Appendix 15-4- Road Safety Audit (RSA)

24032-02-001

PROPOSED WINDFARM DEVELOPMENT AT DERRYADD, CO. LONGFORD.

Road Safety Audit Stage 1

SITE ACCESS B - R398
SITE ENTRANCE DETAILS &
VISIBILITY SIGHTLINES
CONSTRUCT & OPERATIONAL PHASE

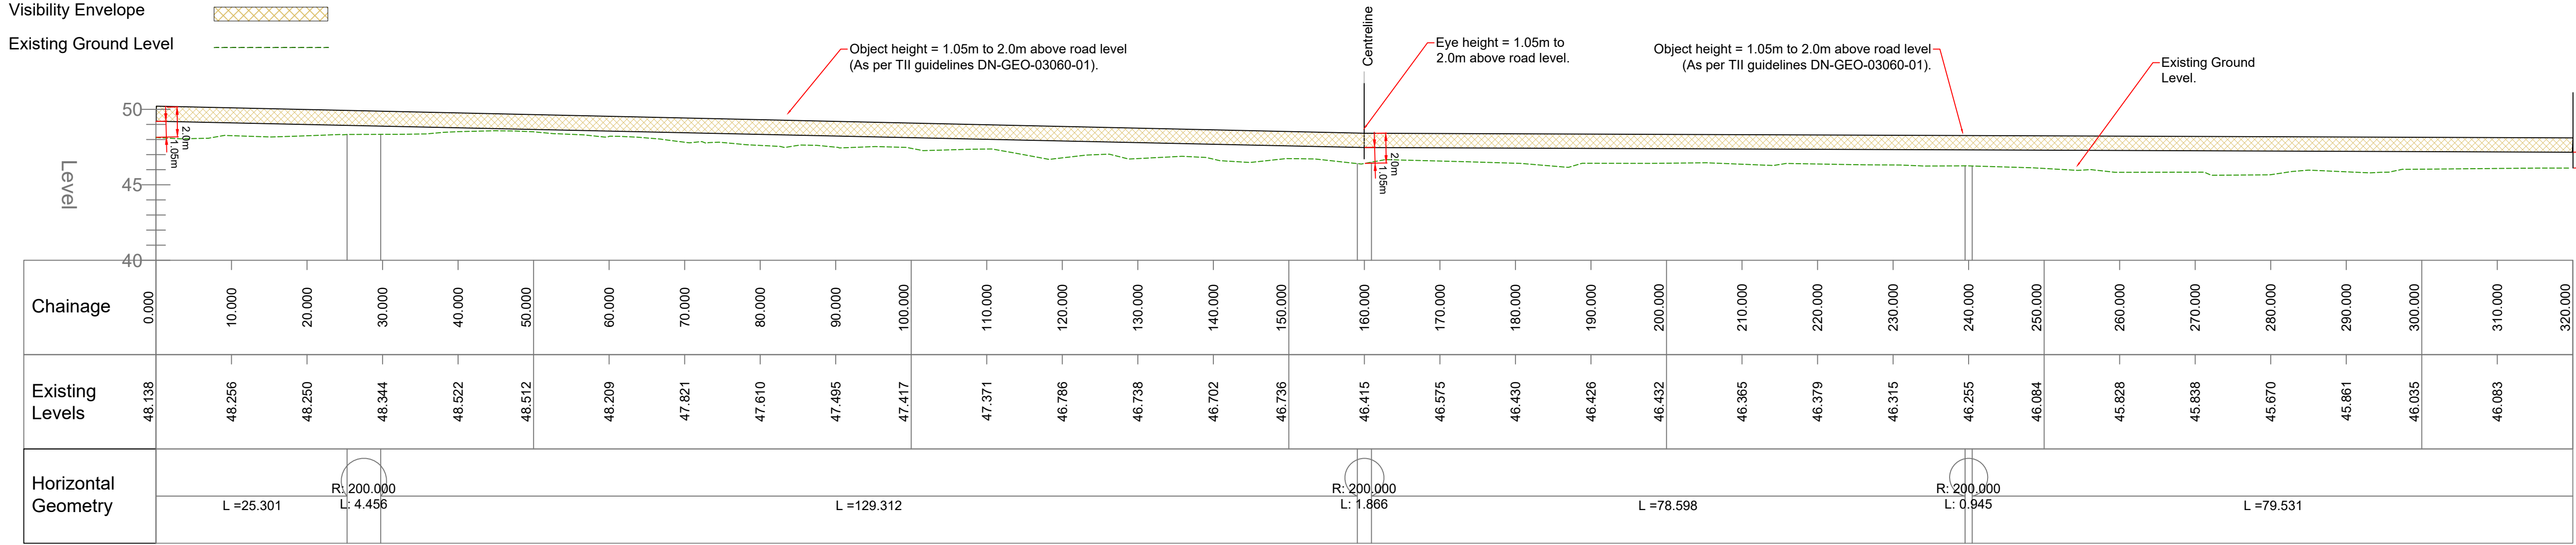
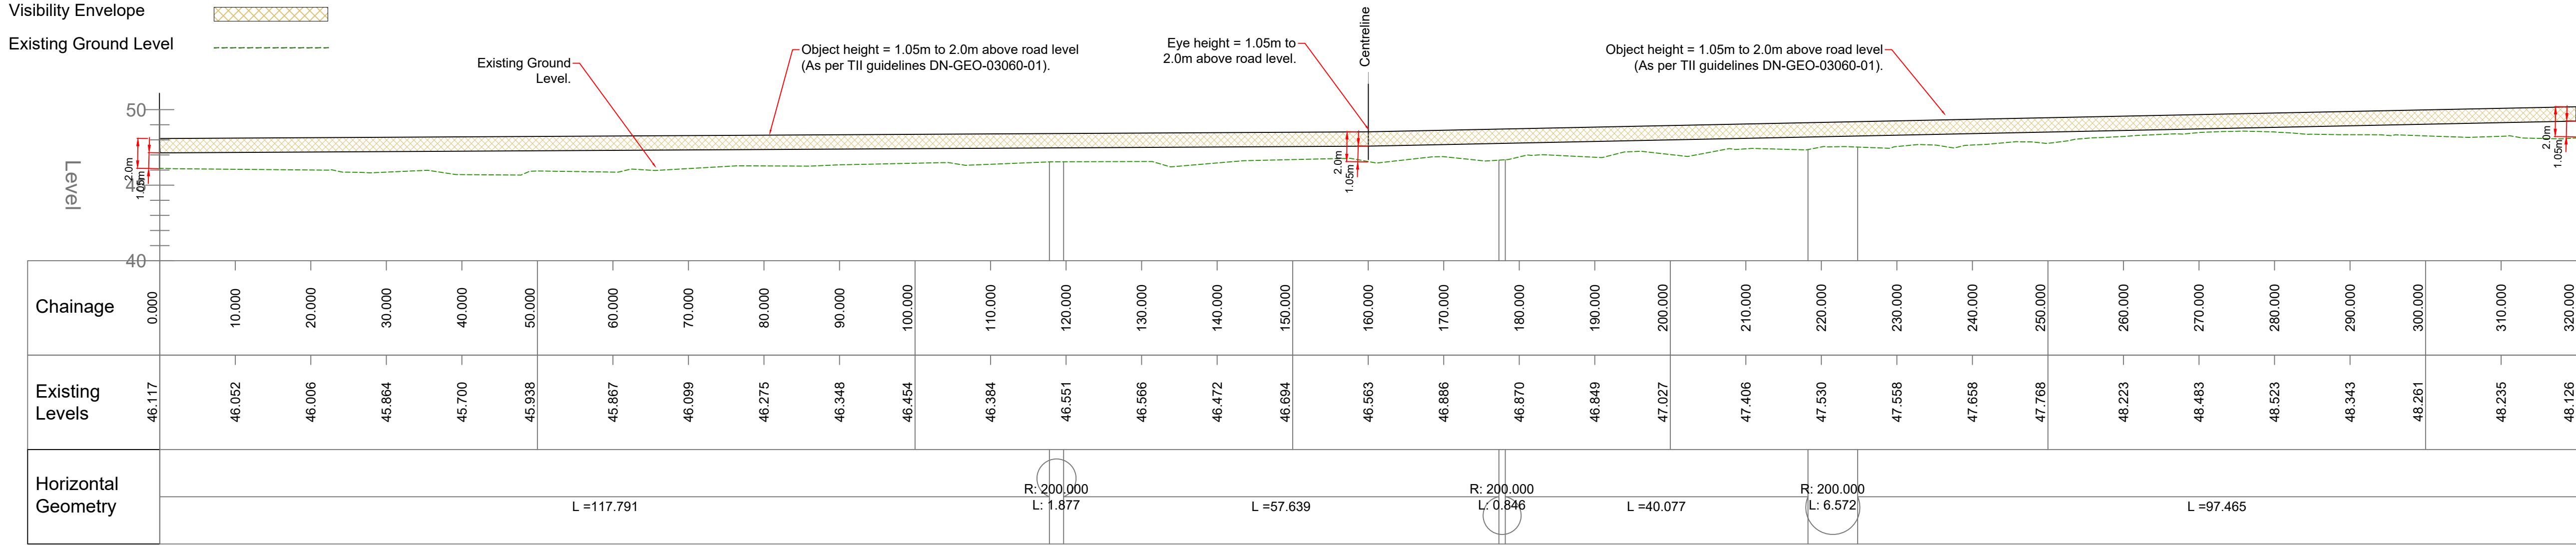
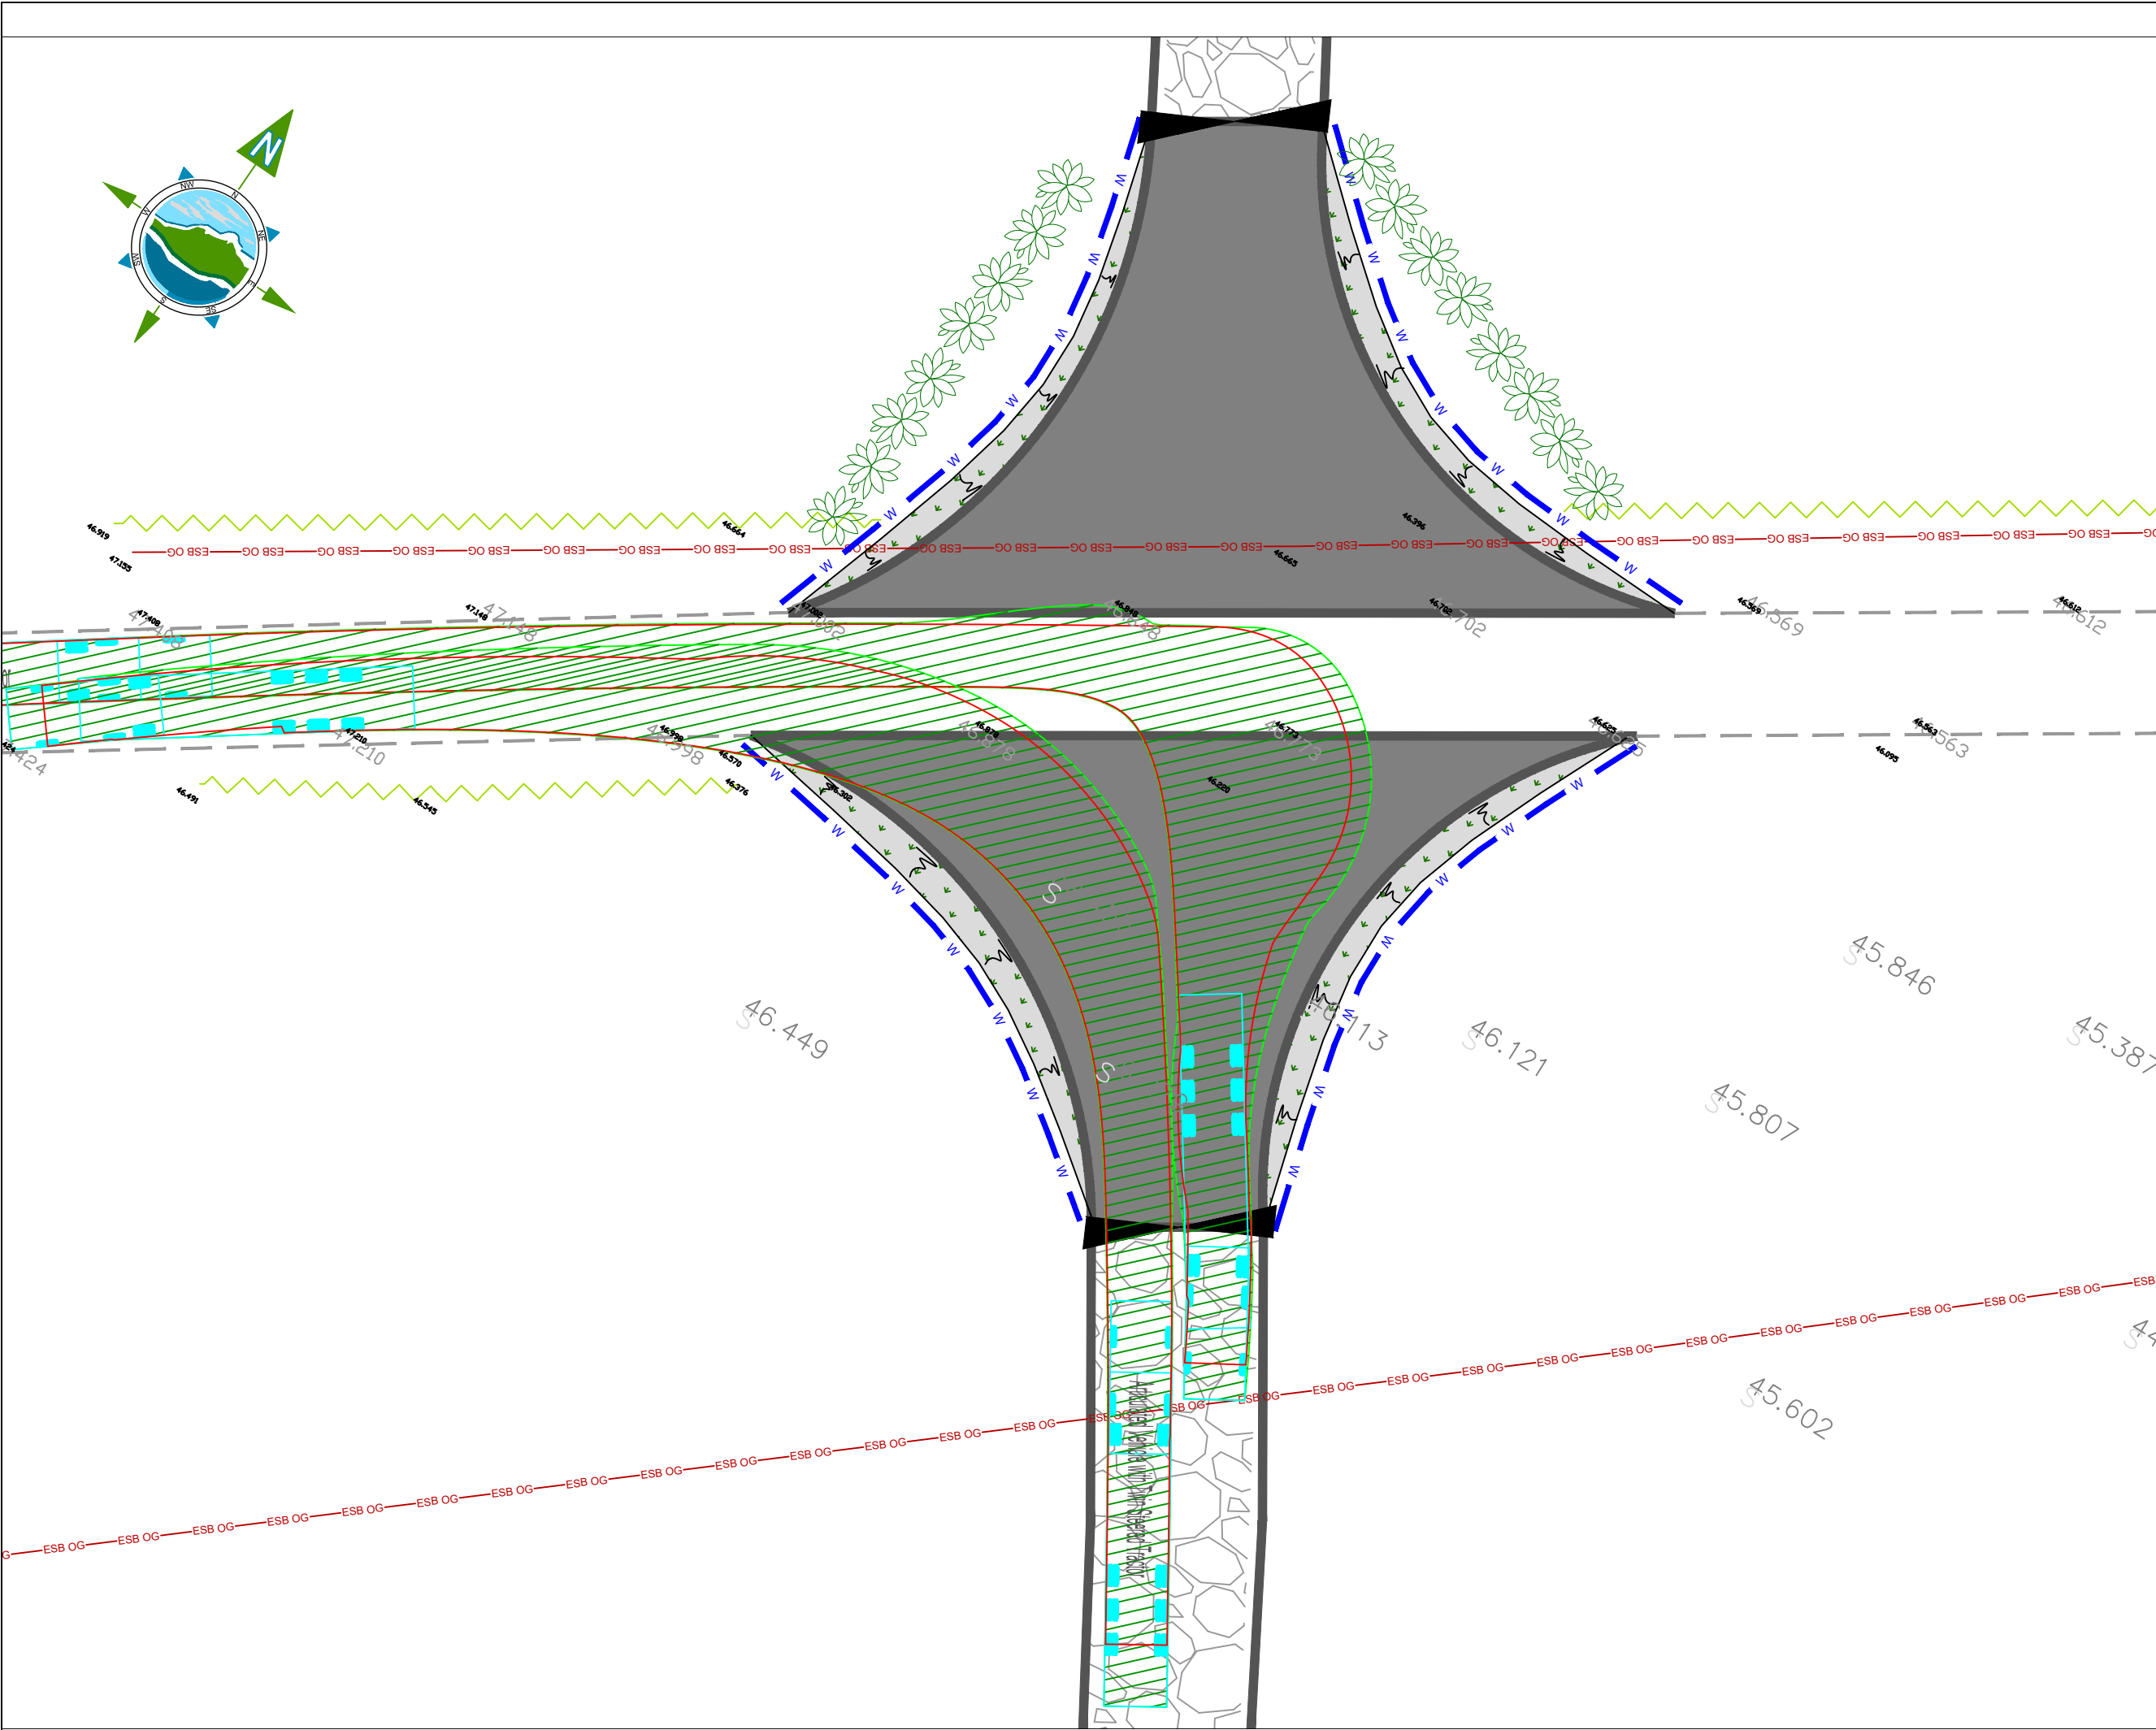
The design drawings indicate that some existing hedgerows are to be set-back for visibility when exiting the site while other sections are to be retained. A lack of a programme of maintenance, issues of ownership of the boundary and regrowth over time may result in the visibility splays being reduced. This may contribute to collisions at the junction when vehicles are exiting the site.

Ensure adequate visibility splays are provided and maintained. Remove the hedge/verge boundary for the extents of the visibility splays.

Title:
**SITE ACCESS C - N63
SITE ENTRANCE DETAILS &
VISIBILITY SIGHTLINES
CONSTRUCTION PHASE ONLY**

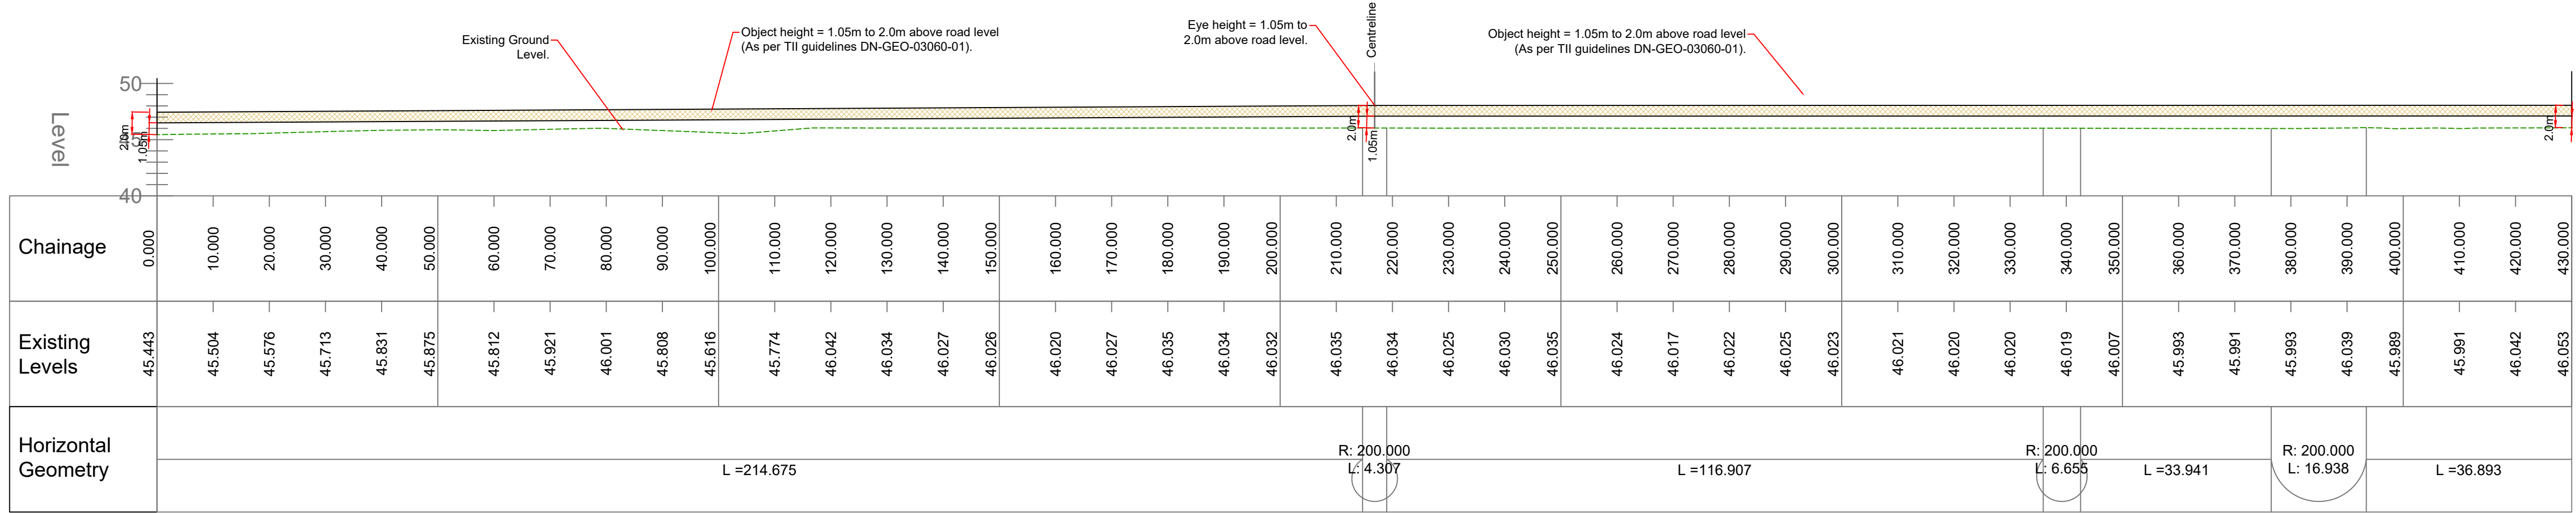
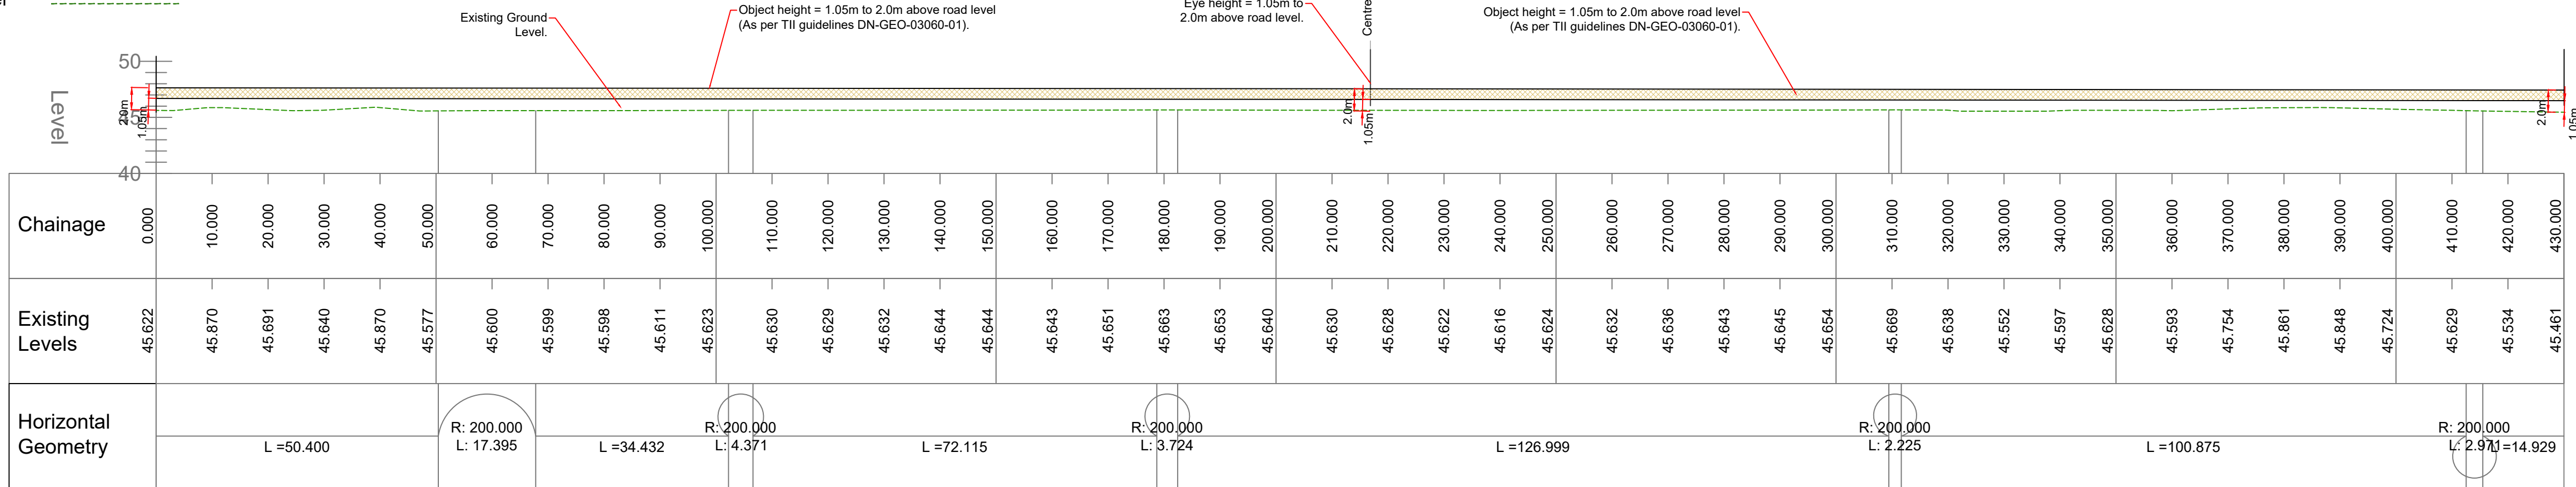
The design drawings indicate that some existing hedgerows are to be set-back for visibility when exiting the site while other sections are to be retained. A lack of a programme of maintenance, issues of ownership of the boundary and regrowth over time may result in the visibility splays being reduced. This may contribute to collisions at the junction when vehicles are exiting the site.

Ensure adequate visibility splays are provided and maintained. Remove the hedge/verge boundary for the extents of the visibility splays.

2.2	Yes	No	No headwall is required within clearzone nor is any new hazards being created.	Yes
2.3	Yes	Yes	-----	-----
2.4	Yes	Yes	-----	-----
2.5	Yes	No	Lands are not within the red line boundary of the scheme .Client will liaise with LA to include the vegetation as part of the annual maintenance.	Yes
